June 8, 2009
NND-09-0152

Subject: V. C. Summer Nuclear Station Units 2 and 3
Docket Numbers 52-027 and 52-028
Combined License Application – Environmental Report Audit
Information Needs: ACC-5 (Part 2), ALT-2 (Part 1), ALT-2 (Part 3), CR-19, and SW-14

VCSNS UNITS 2 and 3

Response to NRC Information Needs Item

Figure ALT-2-3 Possible Site Configuration for Cope Site

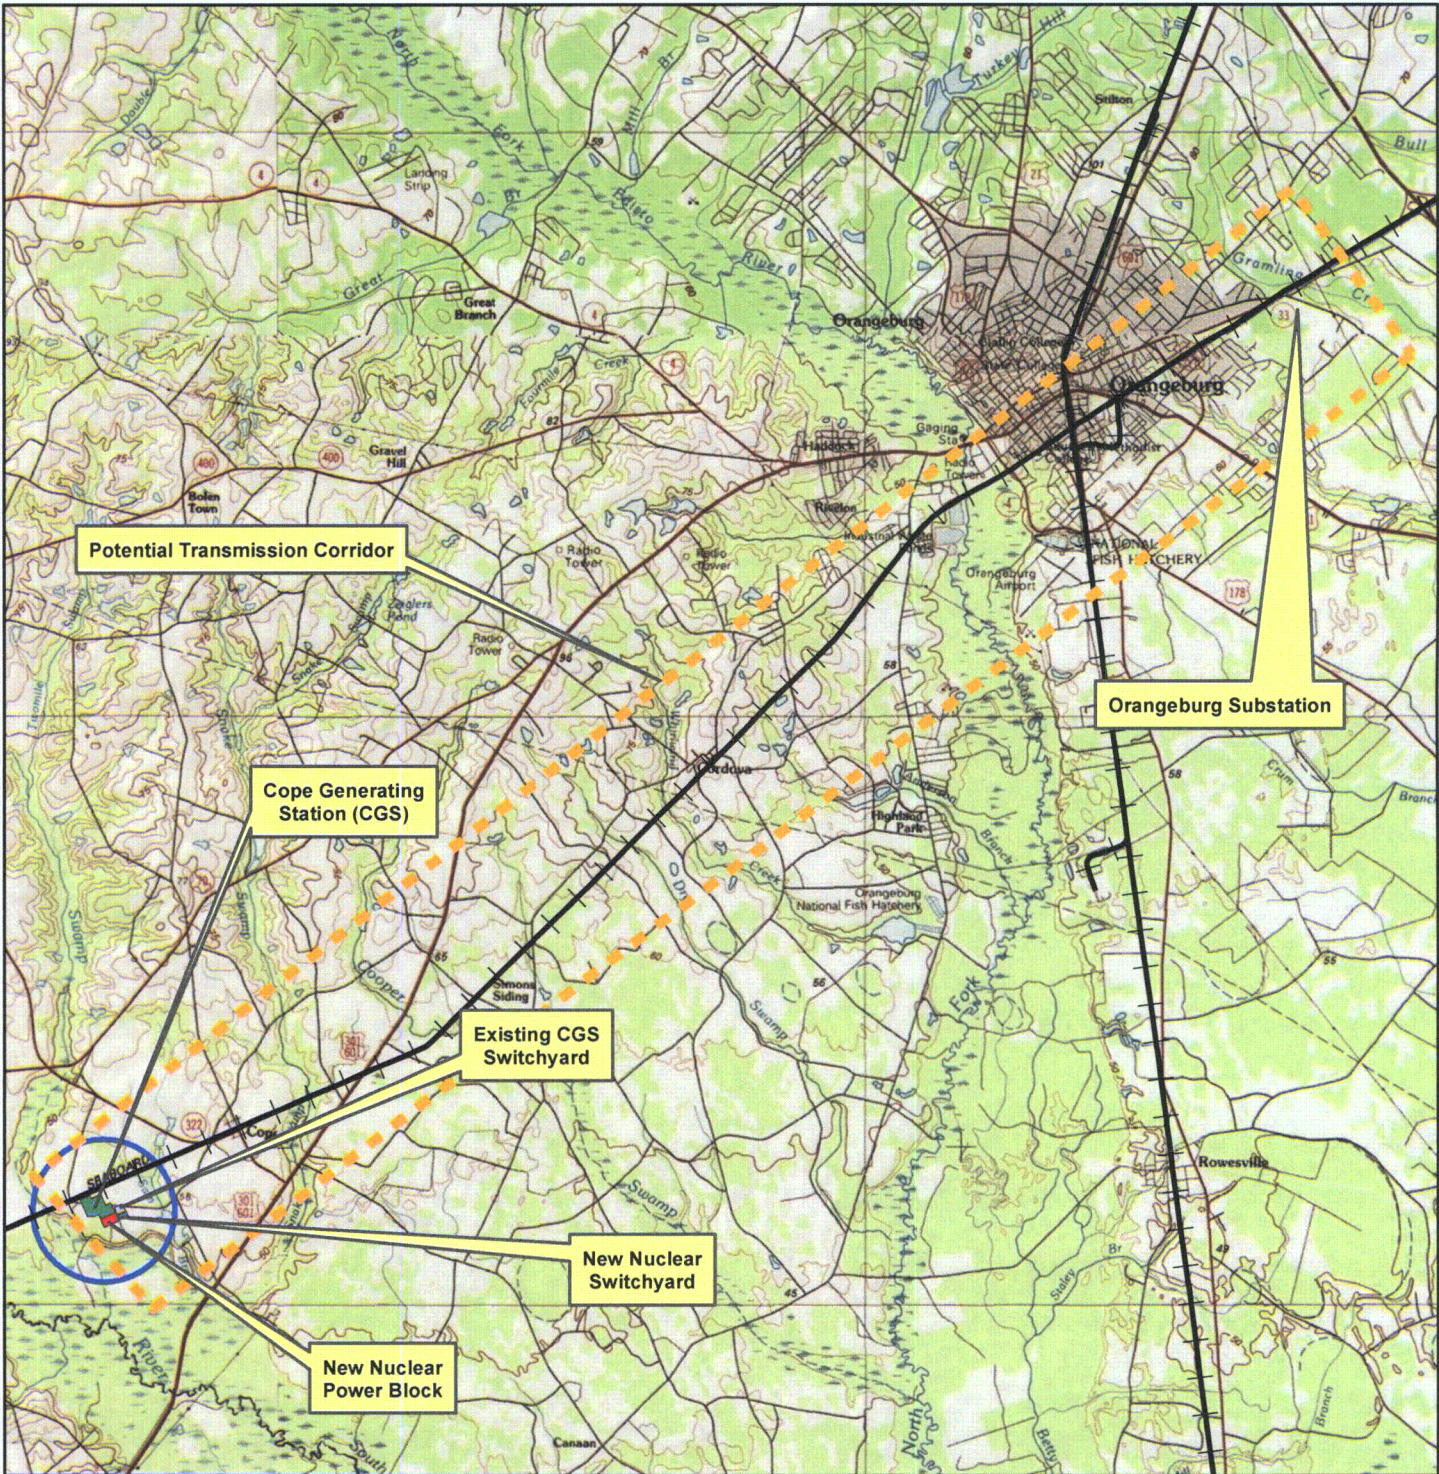
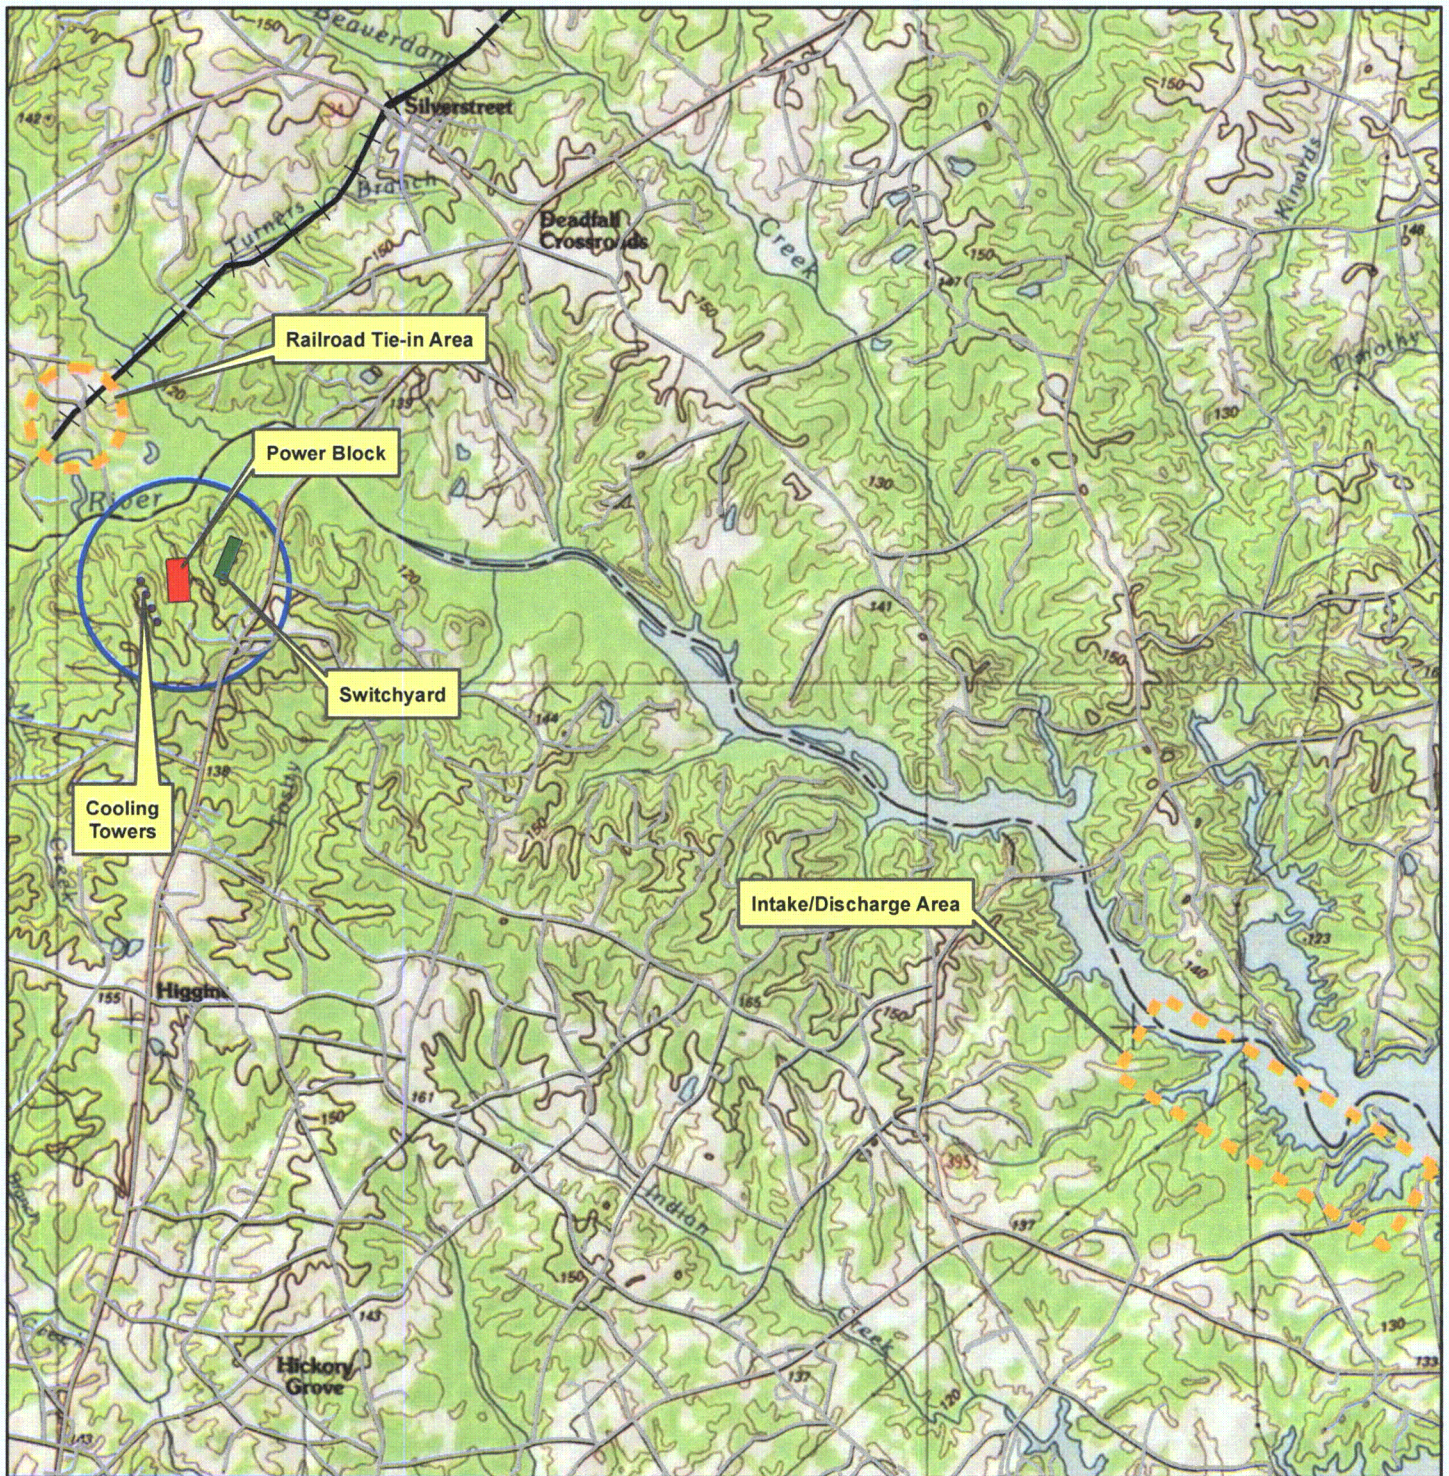
1. Provide revised Section 9.3.2 redesccribing the ROI and how potential sites were identified
2. Provide analysis of additional alternative site FA-1 as a citable reference.
3. Provide information on the configuration of the proposed action on all of the alternate sites, to include power block, cooling tower(s), transmission line corridors, intake and discharge points, etc.

Figures ALT-2-3 and ALT-2-4 show a potential plant configuration and transmission corridors for the Cope Generating Station site.
